**FINAL COMMENTS BY:**

**The Dow Chemical Company  
Louisiana Division**

**Draft Permit NPDES LA0003301  
Dated August 23, 1984**

COMMENTS TO PROPOSED (DRAFT) NPDES PERMIT NO. LA0003301  
DOW CHEMICAL U.S.A., LOUISIANA DIVISION

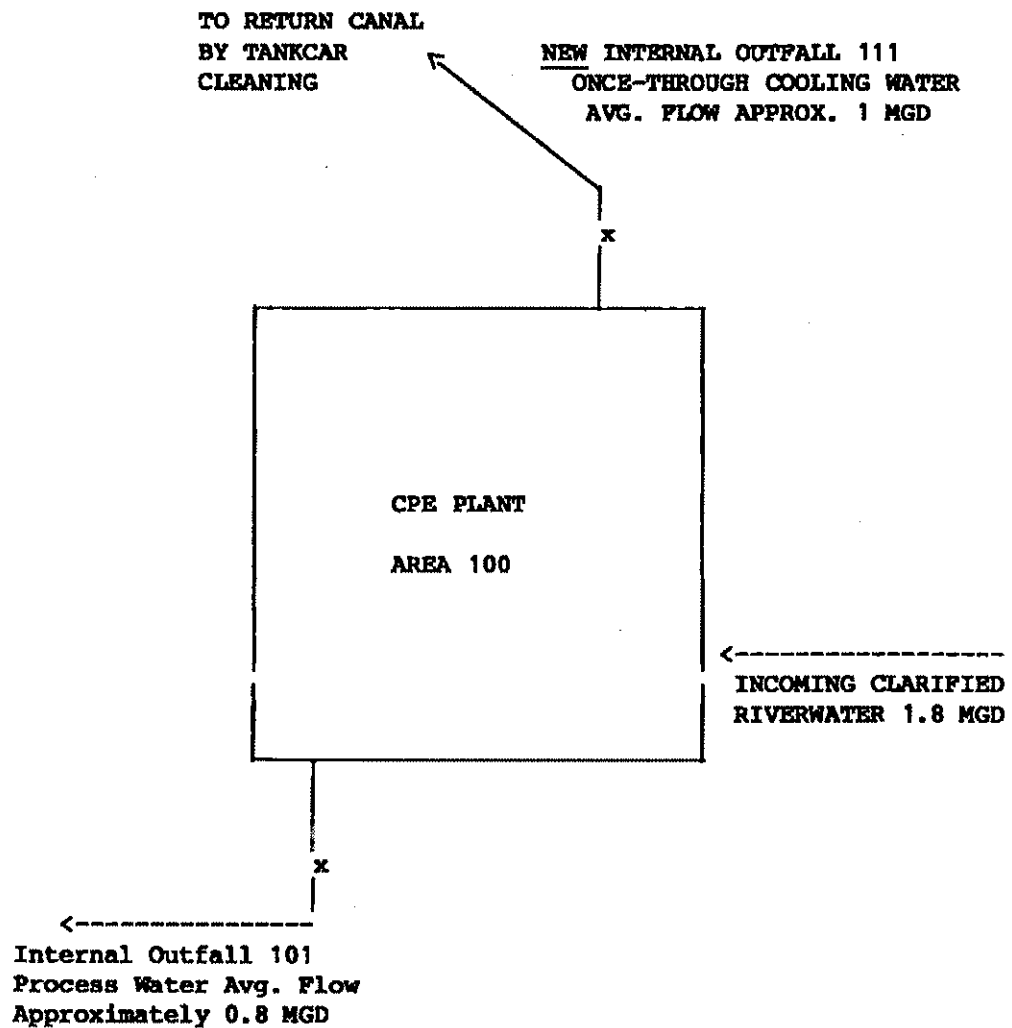
\* REPORT FLOW, TOD, & TSS ONLY UNTIL 1-1-87 ON INTERNAL  
OUTFALL 101

\*\* FLOW ONLY REQUIRED ON INTERNAL OUTFALL III

The pH shall not be less than N/A standard units nor greater than N/A standard units and shall be monitored ~~17/day~~ <sup>N/A</sup> via grab sample.

Page 7 of 127  
Permit No. LA0003301

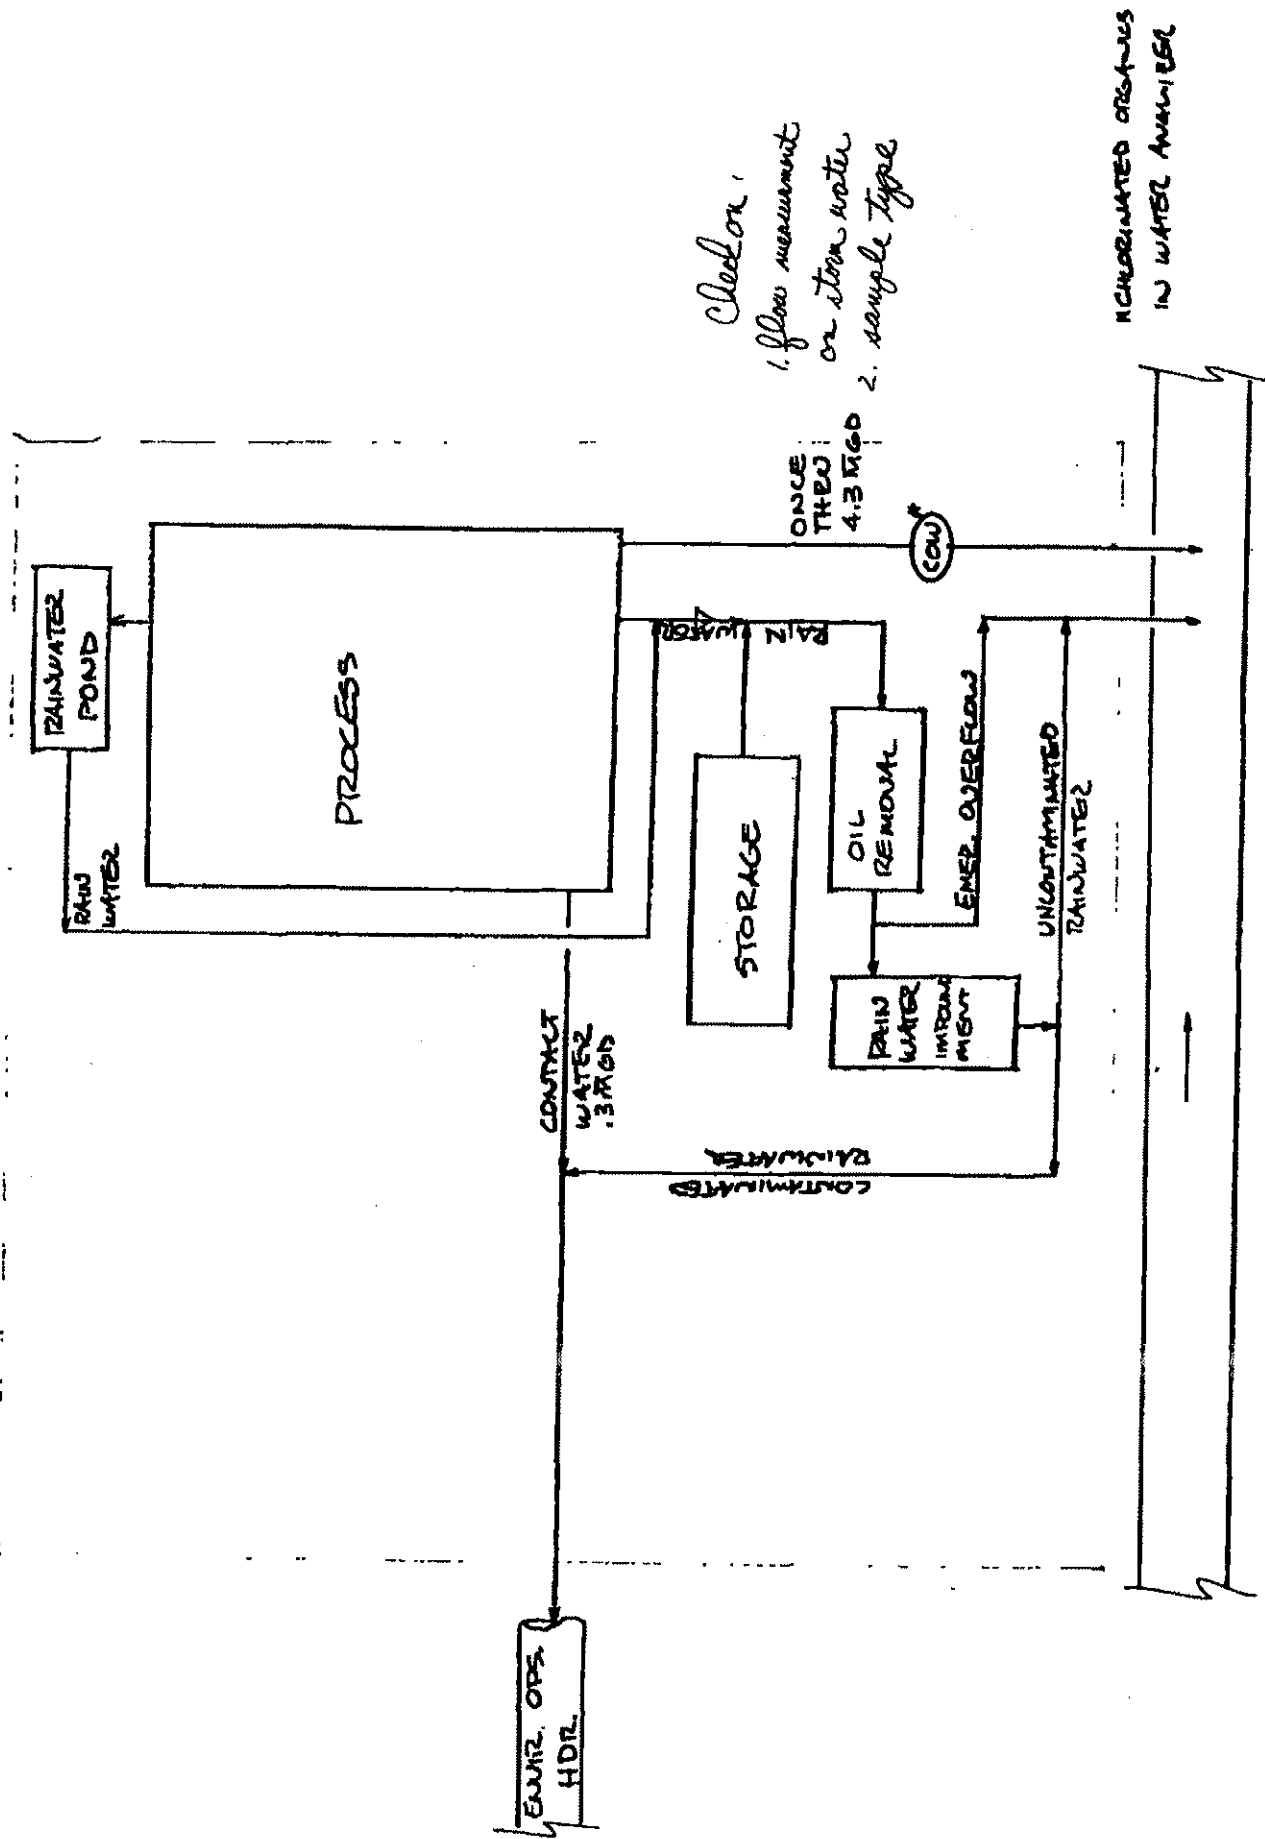
The pH shall not be less than N/A standard units nor greater than N/A standard units and shall be monitored ~~1/day~~ via grab sample.  
N/A

Attached is a block flow diagram showing the Chlorine Plant's discharges into its effluent trench before and after BAT project completion.

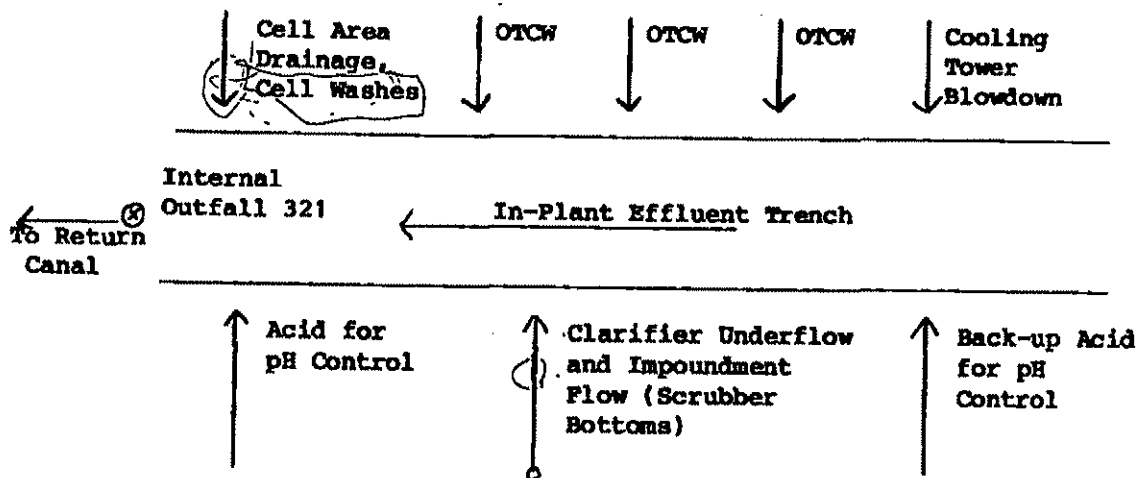
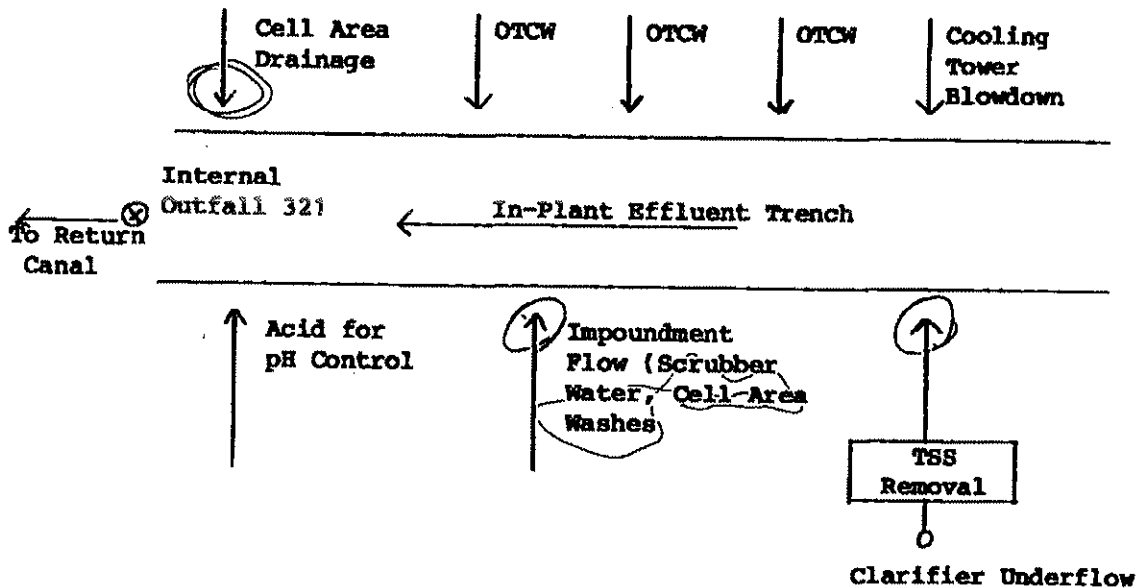
In order to eliminate the variability associated with the sampling and analysis of Mississippi River water, the TSS sampling should take place on the Chlorine Plant's major source of TSS.

The major source of TSS loading from this chlorine production facility results in the discharge of clarifier underflow, which is the brine-treating portion of the plant designed to remove brine solids prior to the brines' use in the chlorine cells. This stream typically consists of 7500 mg/l TSS or an estimated 3600 lb/day TSS.

The best approach would be to sample downstream of the neutralization system, but prior to its comingling with the plant's OTCW.
